MAIN ROADS DEPARTMENT WESTERN AUSTRALIA
PERTH TO DARWIN NATIONAL HIGHWAY
NEWMAN TO WHITE SPRINGS

REPORT AND RECOMMENDATIONS
BY THE
ENVIRONMENTAL PROTECTION AUTHORITY

BULLETIN NO 175
JULY 1984

FIGURE 2

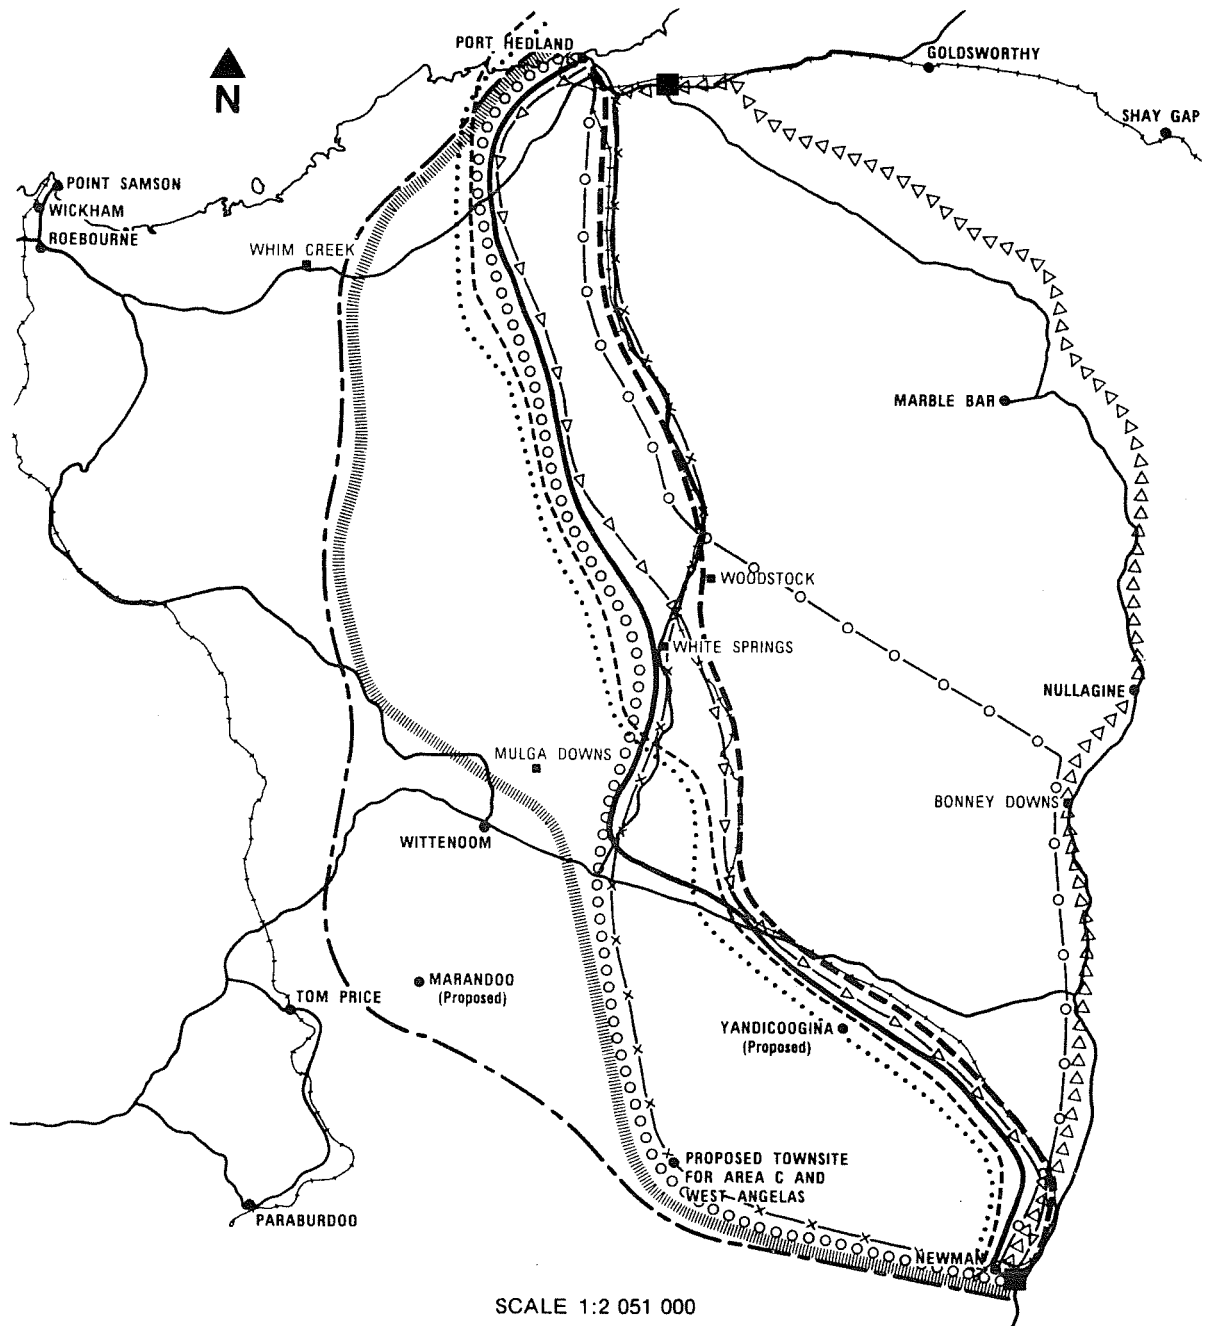
Route 2 was recommended as a more reasonable alternative by a number of respondents. There is little difference between routes 2 and 3 in terms of total disturbance (the length of heavy and major earthworks would be 144km and 139km respectively). Both have the potential for visual impact

in the Hamersley Ranges. However the alignment of Route 2 along the ecotone between the Hamersley Range and the Fortescue Plain would suggest that Route 3 would be preferable as it would be less likely to act as an ecological barrier.

With respect to Route 3, two alternative gorges were considered as alternatives to Munjina East Gorge which is situated in the North Eastern corner of Hamersley Range National Park. The relocation of the route through either of these would result in massive earthworks and severe disruption of these aesthetically attractive gorges. To the south the routes from these alternative gorges would involve crossing the Marillana Flats causing major drainage problems and potential damage to mulga communities through disruption to overland waterflow. In contrast to these difficulties, Munjina East Gorge is wide enough to accommodate the highway and the existing drainage line. Further the extent and depth of cuttings are considerably less than those required for the two alternatives.

The EPA considers that route 3, using Munjina East Gorge is the most prudent of the alternatives considered. In general the proposed highway design in the park should result in landforms that reflect those of the nearby gorges. The EPA believes that the route through the National Park would be environmentally acceptable if recommendations in 4.4.1 to 4.4.8 are adopted.
